**Washington Grove Connector – Crabbs Branch Way Extension Facility Planning Study Briefing**

Staff Recommendation: Approval to Transmit Comments**Summary**

PLANNING BOARD BRIEFING
4-29-2021

Figure 5: Washington Grove Connector – Alternative #3 (Brown Street)

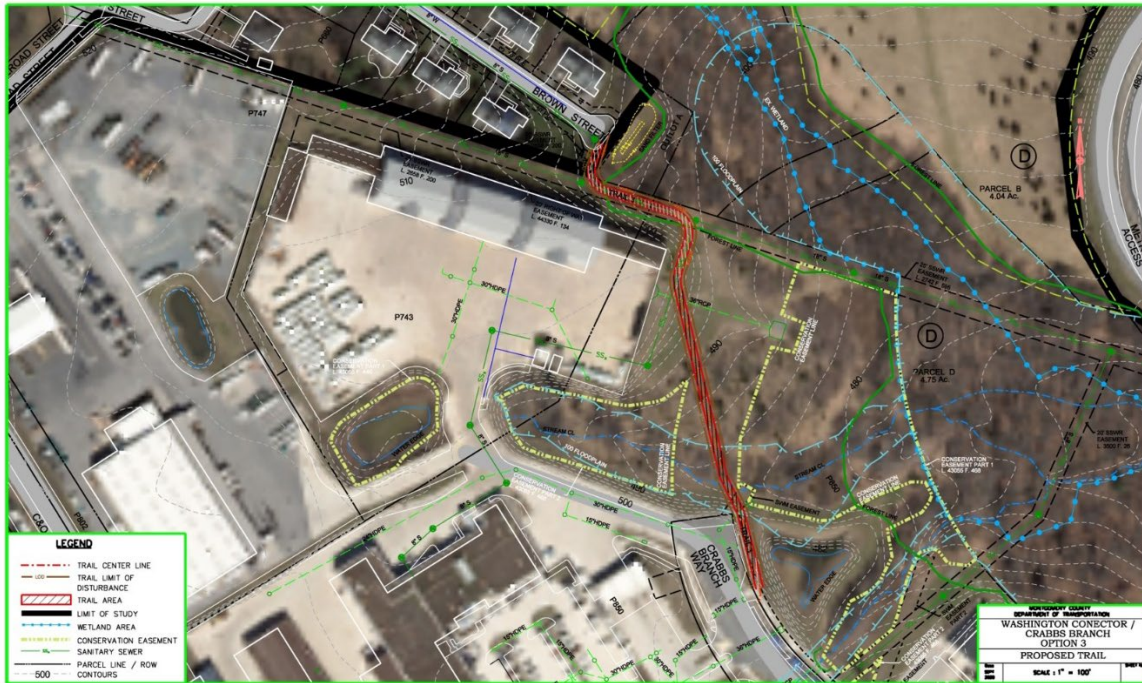
1. Washington Grove Connector Alternative #3 (Brown Street) should be advanced as the preferred trail alignment. This trail should be designed to county typical standards, including a trail width of ten feet with 2-foot wide unpaved, graded shoulders, and with no obstructions within two feet of the trail edge,

Of the alternatives advanced by MCDOT, Montgomery Parks supports Alternative #3 (Brown Street) as the most effective connection from the Washington Grove neighborhood to the end of Crabbs Branch Way. This option provides an efficient connection while minimizing impacts to natural, cultural, and historical resources outlined. Alternative #2 is not supported due to the additional impacts this alignment presents to existing forest, wetland, and meadow habitat, and potential historic/archaeological resources.

Figure 6: Washington Grove Connector – Alternative #4 (Picea View Court)

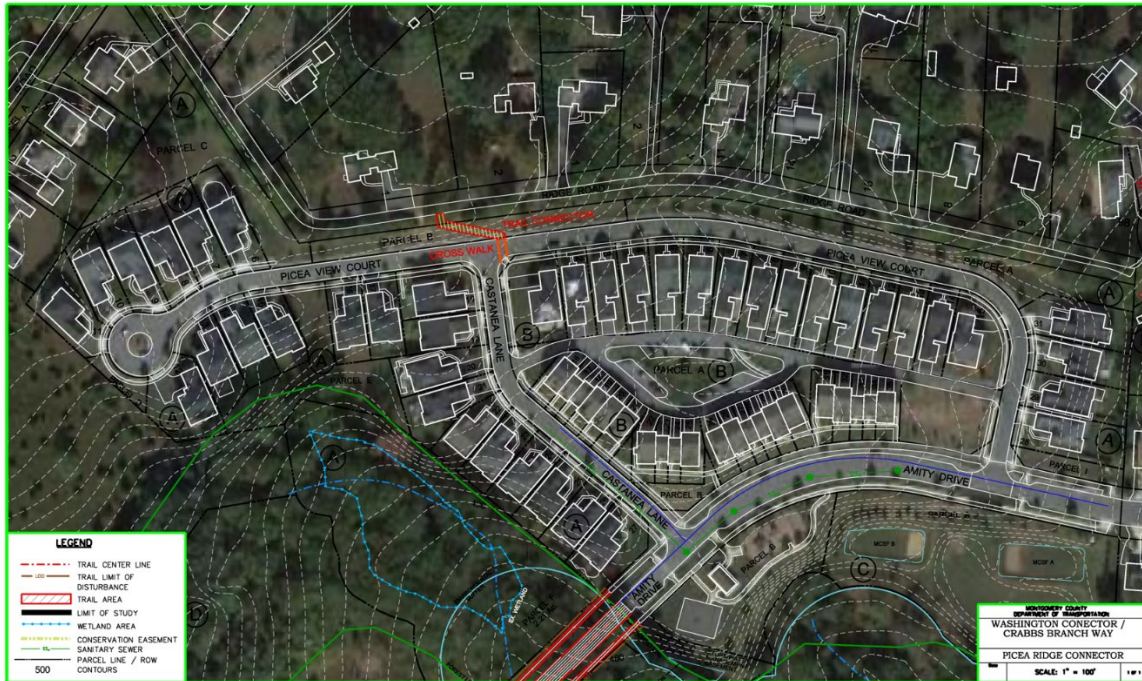
2. Washington Grove Connector Alternative #4 (Picea View Court Connector) should be advanced as an additional trail connection, as it has its own merits/independent utility for connecting the Amity Drive area with the Town of Washington Grove for pedestrians and cyclists,

Table 1 presented below provides a summary of anticipated effects/impacts of three of the four alternatives. During MCDOT’s study, Alternative 4 was not evaluated in the same detail, and from a Planning Department perspective, seems to have independent utility compared to the three alternatives presented below. In general, of the three primary alternatives, Alternative #3 (Brown Street) has the lowest estimated construction cost, the shortest route, and the lowest impact to forested areas. It is also preferable to Alternative 1 because the street that it connects to (Brown Street) is lower volume than the street that Alternative 1 connects to (Railroad Avenue). All Alternatives provide acceptable slopes along the trails under consideration; however Alternative #1 (Railroad Avenue/ Roberts Oxygen) has the lowest maximum slope.

Figure 7: Crabbs Branch Way Extension – Plan View

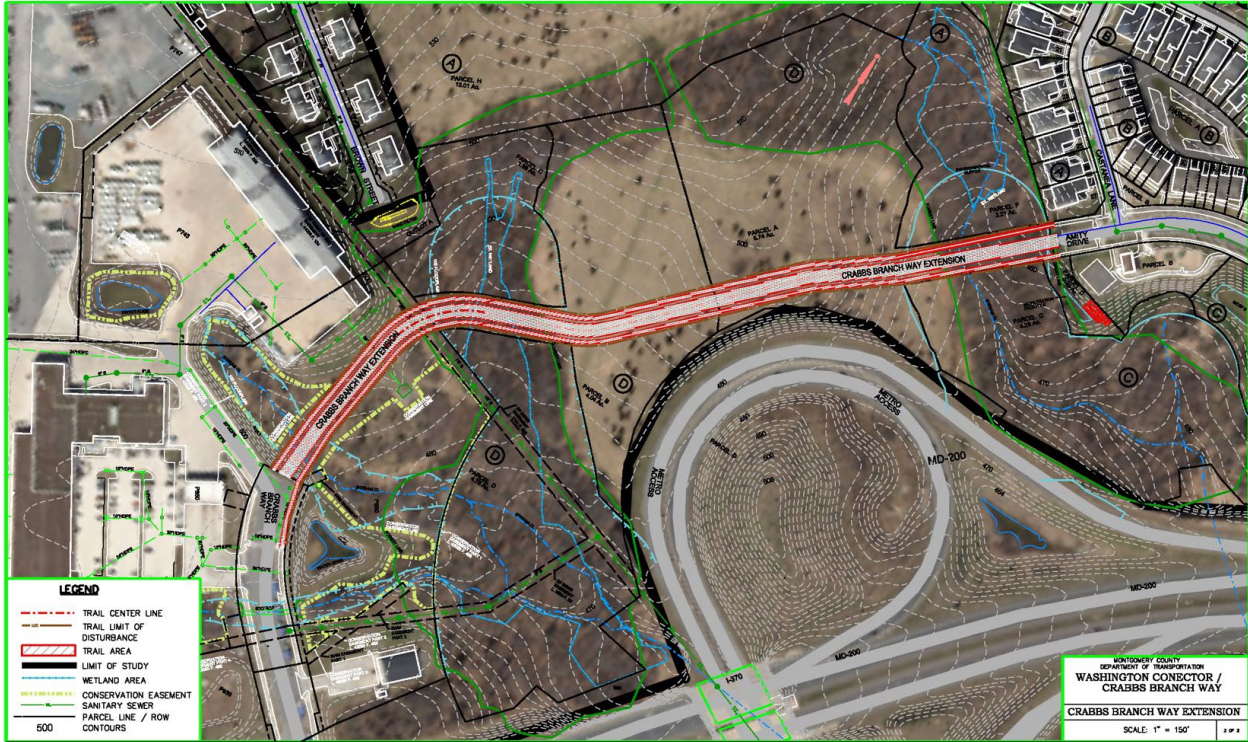
3. The cross section used to design the Crabbs Branch Way Extension should use the Neighborhood Connector street type presented in the Complete Streets Design Guidelines,

4. MCDOT should come back for a second briefing for the Crabbs Branch Way Extension project, once significant study and conclusions are reached for this facility planning study,

Figure 9: Crabbs Branch Way Extension – Amity Drive Trail Connector

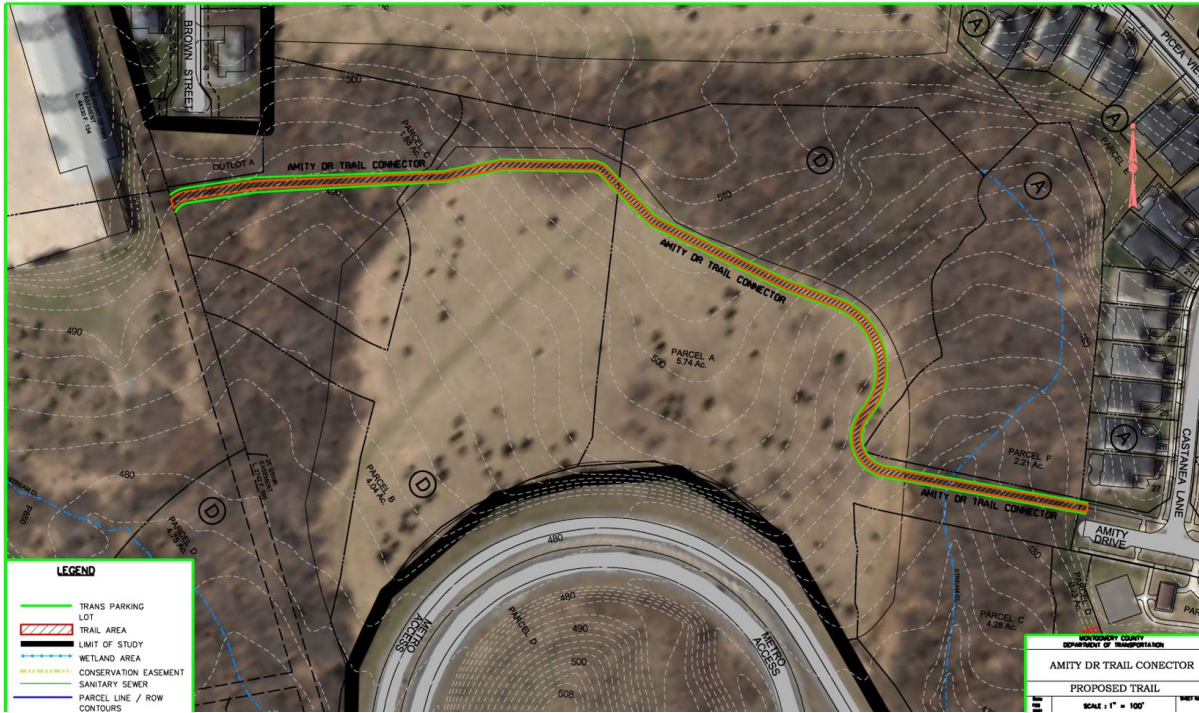
5. MCDOT should re-evaluate the need and alignment for the Amity Drive Trail Connector as presented in the briefing, as this connections could either be accomplished using the Crabbs Branch Way Extension alignment (if this road is constructed) or as a separate trail along generally the same alignment (if the road is not constructed). Montgomery Parks has concerns with the alignment shown during this briefing and has noted the existence of an unsigned, people's choice trail that would be preferable.

The proposed Amity Drive Connector Trail would impact and replace a section of the existing natural surface trail on Piedmont Crossing Local Park. A trail connection in this location would only be considered once the evaluation of the Crabbs Branch Way Extension project is complete. If the roadway is extended, the trail alignment should follow immediately adjacent. A natural surface trail connection from the end of Amity Drive to the existing Natural Surface Trail loop in the park should be a consideration as part of the overall trail plan where an unsigned people's choice trail exists now. Signs, a kiosk at Amity Drive, and a small bridge would be needed to make this connection official. The master planned road alignment would have significant impacts to the existing recreational, environmental, and historic resources in the park.

Alignment #2 – Ridge Road Survey Comments

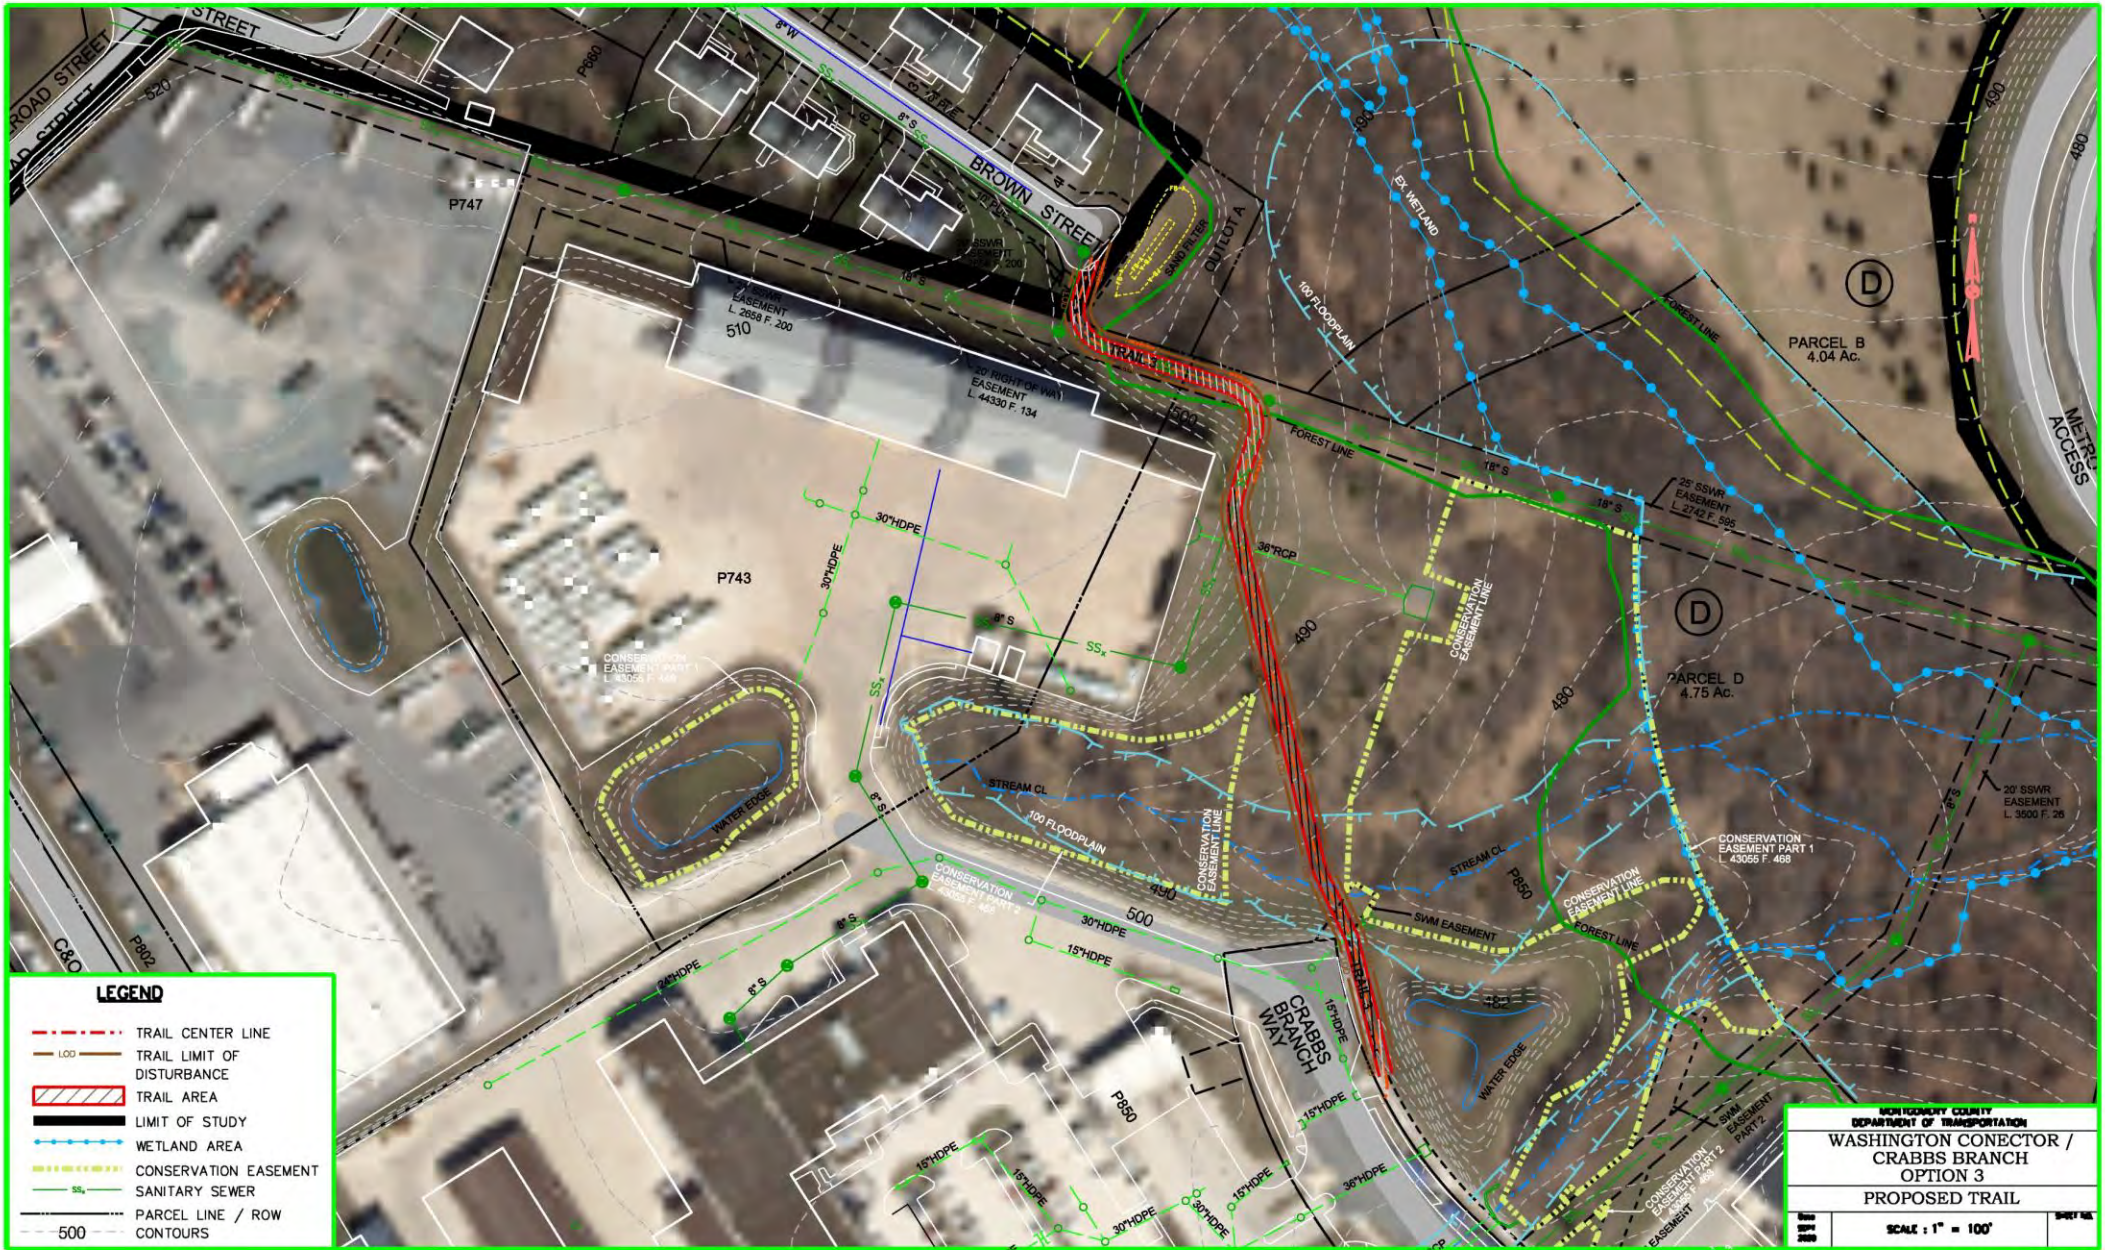
- Expensive and environmentally impactful to conservation meadow
- Close to backyards
- Requires paving parkland
- Sacrifices natural meadow to avoid Brown St
- Minimizes impact to Brown St residences
